2015.10.23 - Helium Polish version 5.6.79.1, report.dll version 2.7.3.1, BrilRecon.dll version 1.1.12.1, OHWS\_reflect2.dll 1.5.63.533, new templates dd 15.09.2015

In this version we made following changes:

Report.dll 2.7.3.1	Report.dll 2.6.11.1
--------------------	---------------------

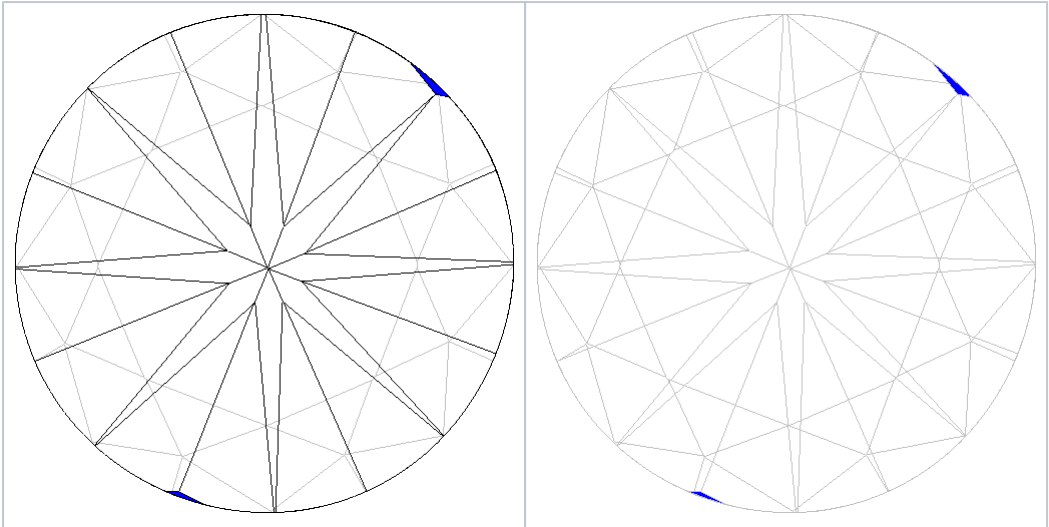
7. Problem with visible and invisible edges color is fixed. Visible edges had same color with invisible edges in report.dll 2.6.11.1. Fixed in report.dll 2.7.3.1:

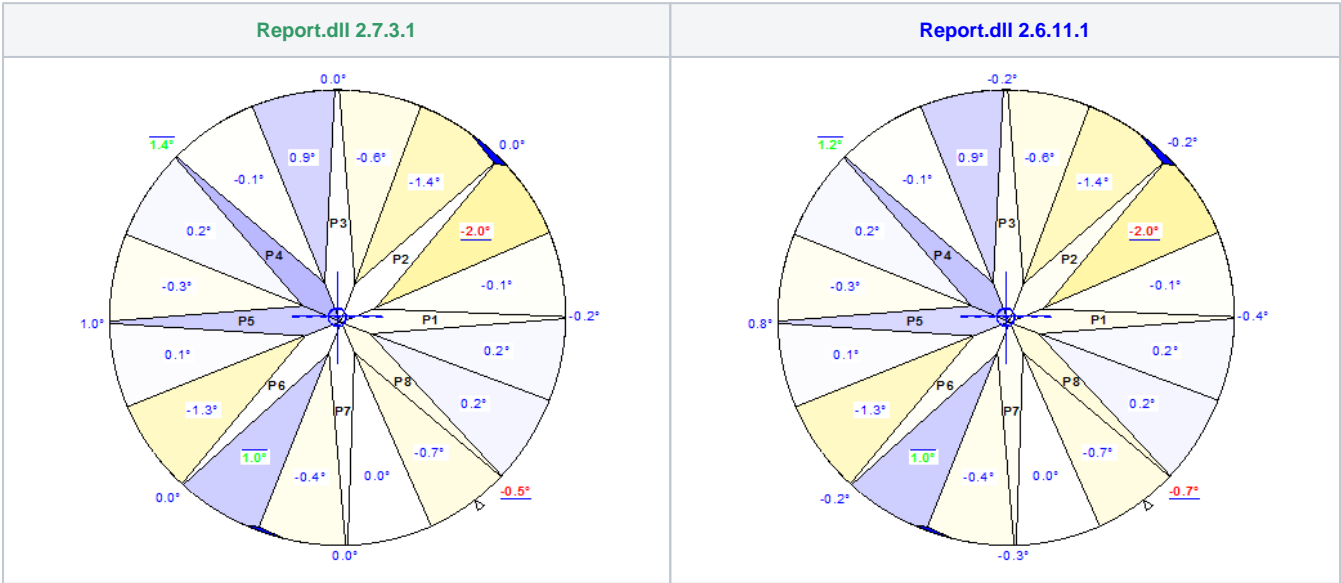
8. Change in calculation of "ideal" position for pictures «Pavilion/crown painting and deviation of pavilion/crown main facets azimuths angles from their ideal positions for the round brilliant». Before there was standard "net" 0, 45, 90, 135,.....,315 degrees for "ideal" position. From this version program calculates position to minimize means-square deviation and to have as more as possible deviations which are closed to «0».

Changes are visible in Full report for bookmarks PAVILIONAZIMUTHDEV\_REPORT\_COLOR, CROWNAZIMUTHDEV\_REPORT\_COLOR, PAVILION\_AZIMUTH\_DEV\_PICTURE, CROWN\_AZIMUTH\_DEV\_PICTURE.

On example below, 4 facets deviations are equal to «0»:

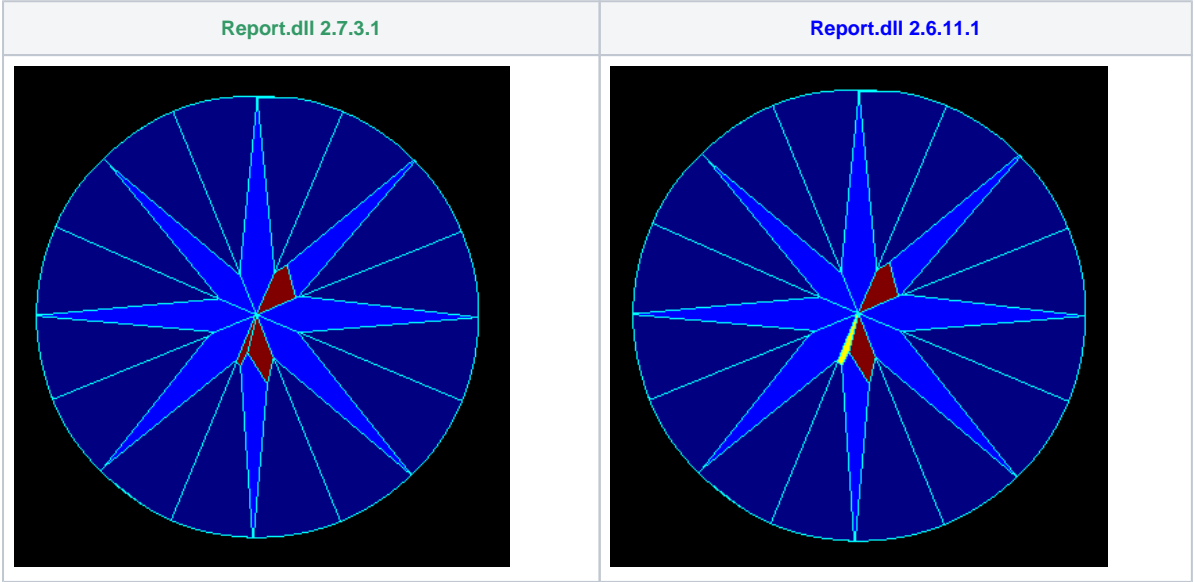
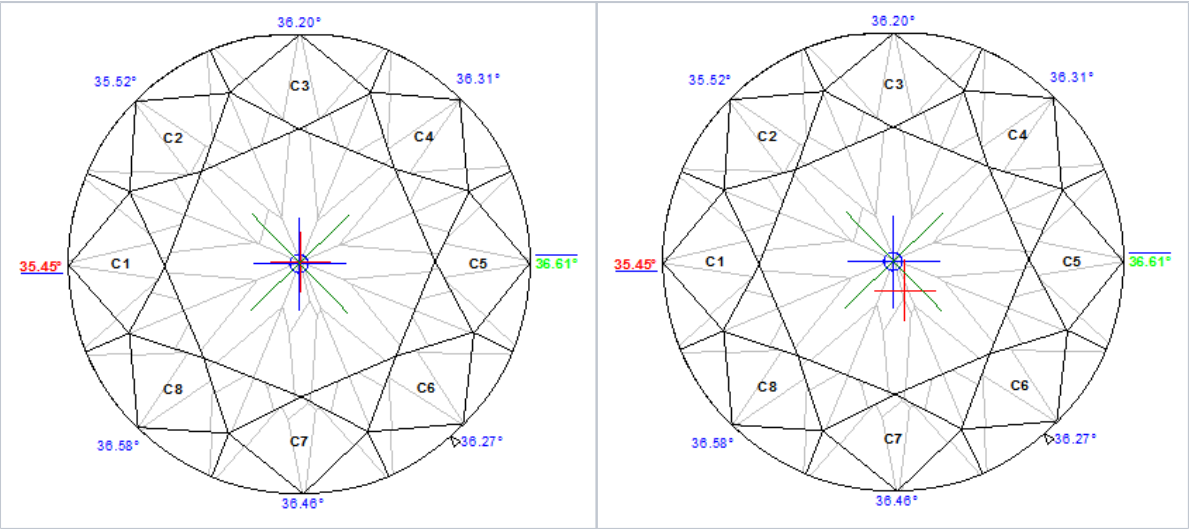
9. Bug with wrong detection of semi-polished *Heart* is fixed. In previous version (report.dll 2.6.11.1) semi-polished heart was recognized as *Oval* cut. From current version (report.dll 2.7.3.1) semi-polished heart is recognized as *Heart* cut.
